SAFETY ALERT

Servo Tab Spring

SA-LTUL-CTSW-02

Technical Advice No. 12e
 November 1st, 2006

Fig. 1

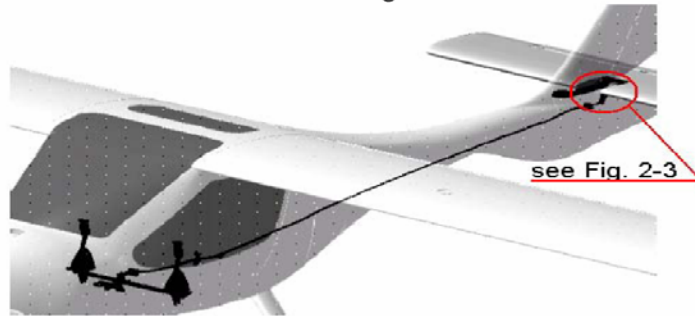
It was found that the anti-servo tab spring could, *under extreme conditions*, cause a sudden change in trim force pressure. This could result in a sudden pitching down movement of the aircraft that is most pronounced as Vne is reached or exceeded.

Action:
 Flight Design is mandating a modification of the trim system on the affected aircraft that consists of replacing the original spring and associated spacer and washer with a new spring and telescopic spring guide assembly (Fig. 1)

Fig. 2 (Old)

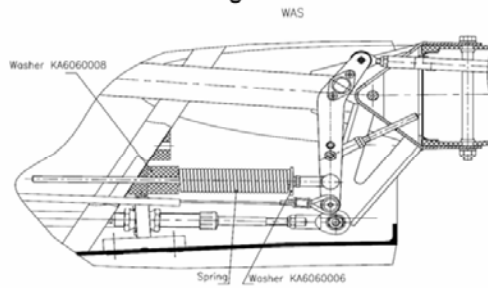
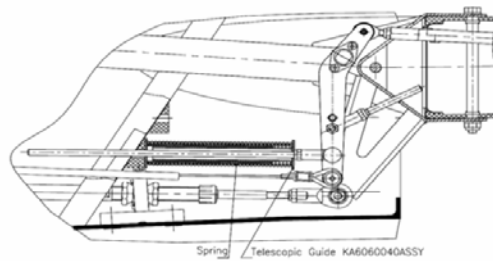
- Important:
- A. The new spring is longer than the original (37 (Fig 3) windings instead of 35 windings). The original one is too short and must not be used.(Fig 2)
 - B. The movement of the original, shorter spring is limited at one end by a plastic spacer (KA6060008) and at the other end by a washer (KA6060006) (Fig 2). These parts are also not reused.
 - C. When mounting, the gliding surfaces of the telescope and the surfaces contacting with the spring have to be lubricated by use of Aeroshell Grease 6 or equivalent, to support frictionless operation.
1. Mount the stabilizer in accordance with the Maintenance Manual and check for correct operation.
 2. Tag the original spring with the aircraft serial number and return to Flight Design.
